E2E UI PROJECT 1791417522799 - FACILITY AUDITS REPORT

E2E UI FACILITY 1791417522799

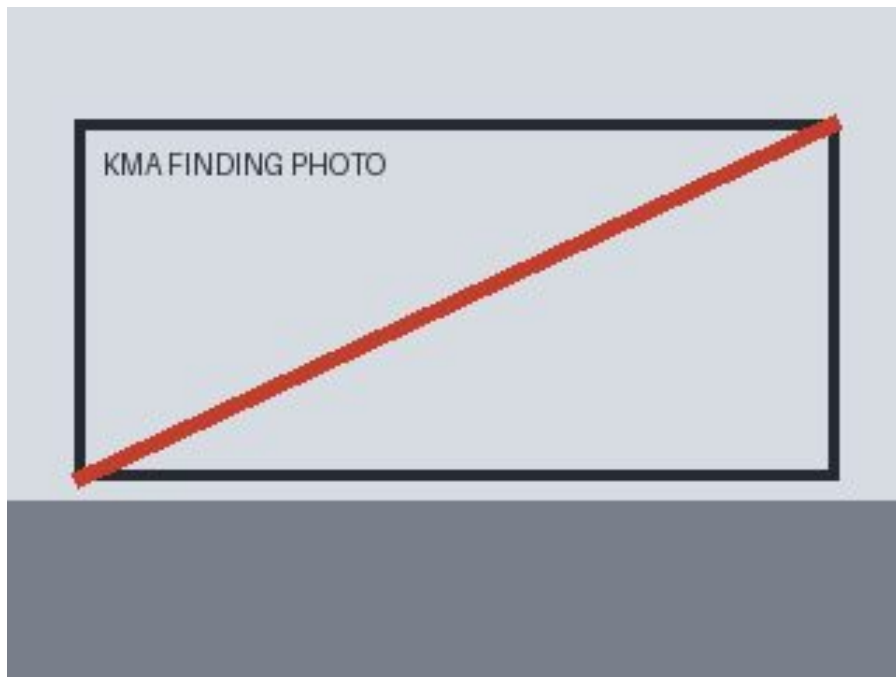
#	Barrier Statement	Code	Photo	Proposed Mitigation	Cost
1.	The curb ramp is not located on an accessible route. Measurement: 9.5% Location: UI entrance	ADAS 402.2		Rebuild the curb ramp on an accessible route. Quantity: 3 Unit Cost: \$1,250 EA	\$3,750
TOTAL FOR E2E UI FACILITY 1791417522799: \$3,750
